CORRECTIVE ACTION PLAN

Aspen Meadows Neighborhood

February 22, 2022
Amended January 13, 2023

Photo AMN7 – Dwelling Unit C6 - Measured height of clothes rod at 65 1/2”.

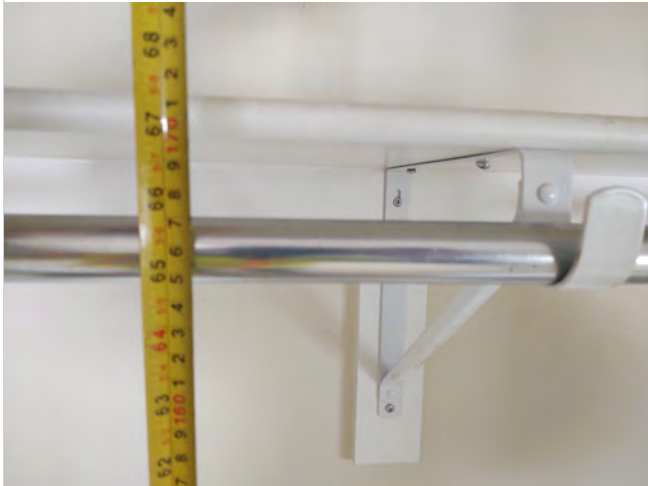
4.25.3 and 4.2.6	Storage - Height	Clothes rods shall be a maximum of 54" from the floor.	The measured top of the clothes rod exceeded 54".	AMN #6 & AMN #7	The existing clothes rod is to be lowered to not more than 54" above the floor.	The labor to relocate the clothes rod is approximately 1 hour for a labor cost of \$70.00.	\$70	\$70

Photo AMN8 – Dwelling Unit C6 - Water closet with grab bars.

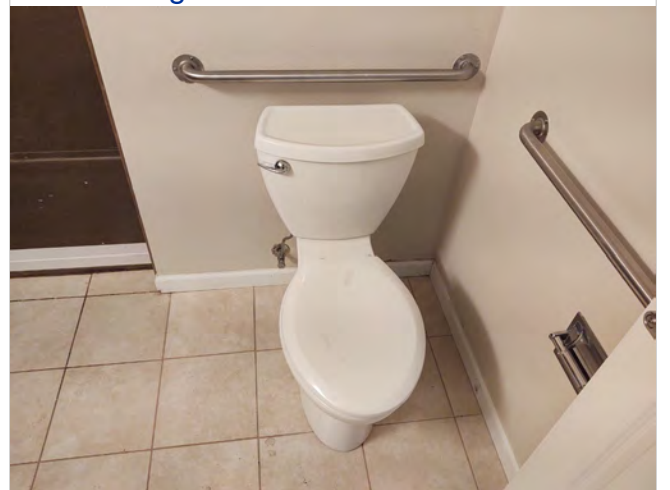
4.34.5.2 (3), 4.26, and Fig. 29	Rear Wall Grab Bar	The rear wall grab bar is no more than 6 inches from the side wall and 32 inches long.	The measured distance from the rear edge of the rear wall grab bar is 3". The measured distance from the side wall to the far edge of the rear wall grab bar is 33". A 30 inch long rear grab bar has been installed.	AMN #8, AMN #9, & AMN #10	A new 32" long rear wall grab bar is to be installed with the rear edge 6" from the side wall.	The estimated cost of the new rear wall grab bar is \$50.00. The labor to remove the existing grab bar and install the new rear wall grab bar is approximately 5 hour for a labor cost of \$350.00. Therefore, the parts and labor estimated construction cost would be \$400.00.	\$65	\$65
